Access Compliance Report

Public Rights-of-Way

(Curb Ramps)

Intersection ID: 10034609	Main Street: PLANTATION_CENTER_DR	Cross Street: N/A	Location: S
ADA ID: 02DB41E0A955	Ramp Type: Para	Initial Pass/Fail: Fail	Overall Compliance: No
Codes/Mitigation Info/Possible Solution		Field Measurements/Component Compliance	
Severity Score: 26.25

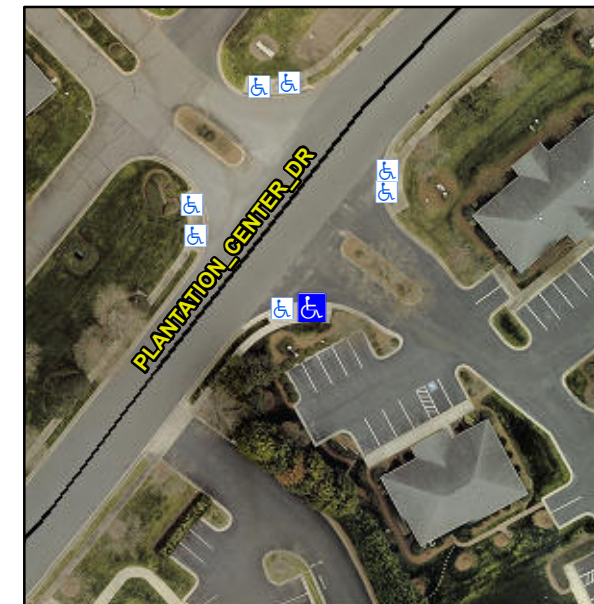
Remove & Replace Entire Ramp.

R304.3.2, R304.5.3

Compliance	Description	Data	Compliance	Description	Data
N/A	Ramp Length LT (in)	54.0	N/A	Ramp Length RT (in)	62.0
Yes	Ramp Width LT (in)	96.0	Yes	Ramp Width RT (in)	96.0
No	Ramp Slope LT (%)	14.0	Yes	Ramp Slope RT (%)	6.8
No	Ramp XSlope LT (%)	2.3	No	Ramp XSlope RT (%)	2.8
N/A	Landing Length (in)	N/A	N/A	DWS Provided?	N/A
N/A	Landing Width (in)	N/A	N/A	DWS Contrast?	N/A
N/A	Landing Slope (%)	N/A	N/A	DWS Length (in)	N/A
N/A	Landing X Slope (%)	N/A	N/A	DWS Full Width?	N/A
N/A	Landing Curb? (Y/N)	N/A	N/A	DWS Offset (in)	N/A
N/A	Shared Landing?	N/A			
N/A	Gutter Ponding?	N/A	N/A	Gutter Slope (%)	N/A
N/A	Gutter Lip Ht (in)	N/A	N/A	Gutter X Slope (%)	N/A
N/A	Painted X Walk1?	No	N/A	Painted X Walk2?	N/A
	X Walk 1 Direction	To NE		X Walk 2 Direction	N/A
N/A	X Walk 1 Width (in)	N/A	N/A	X Walk 2 Width (in)	N/A
	X Walk 1 Slope (%)	0.2		X Walk 2 Slope (%)	N/A
	X Walk 1 X Slope (%)	1.9		X Walk 2 X Slope (%)	N/A
N/A	Ramp inside XWalk1?	N/A	N/A	Ramp inside XWalk2?	N/A
